Staff Report

Design Review Board

File Number: 8-C-21-DT

Project: McWhorter Building

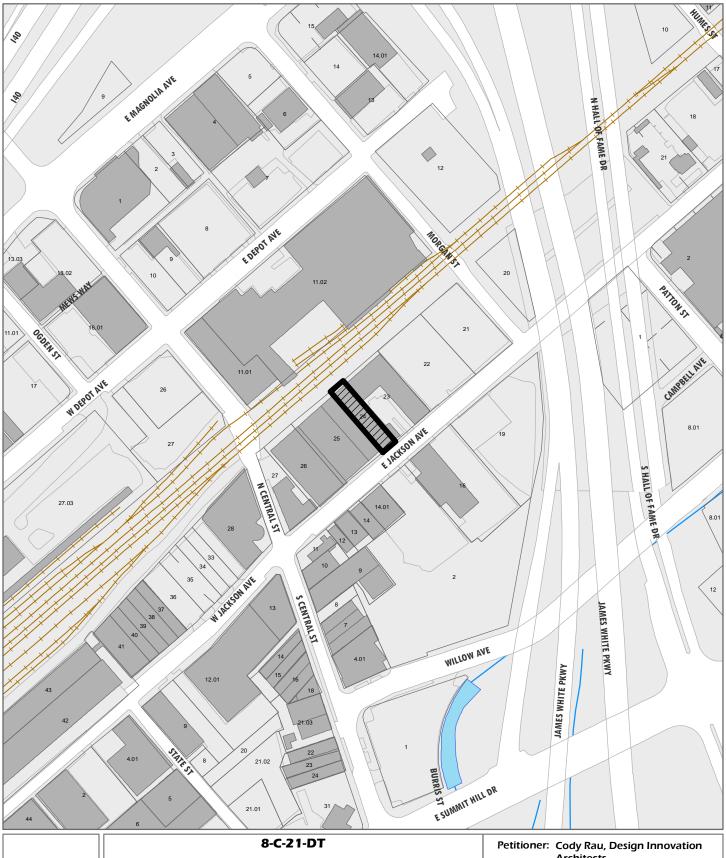
The proposed new occupiable roof deck includes an approximately 10' tall stair enclosure addition clad in metal paneling. The applicant has provided a line-of-sight illustration from E. Jackson Ave, to show the stair enclosure would not be visible from immediately across the street. It may be somewhat visible from points further east on E. Jackson Avenue. The addition is set back approximately 35' from the roofline. The stair enclosure addition, railing, and rooftop deck elements do not alter or obscure any historic features of the building and could be removed with no further effect on the historic character of the building
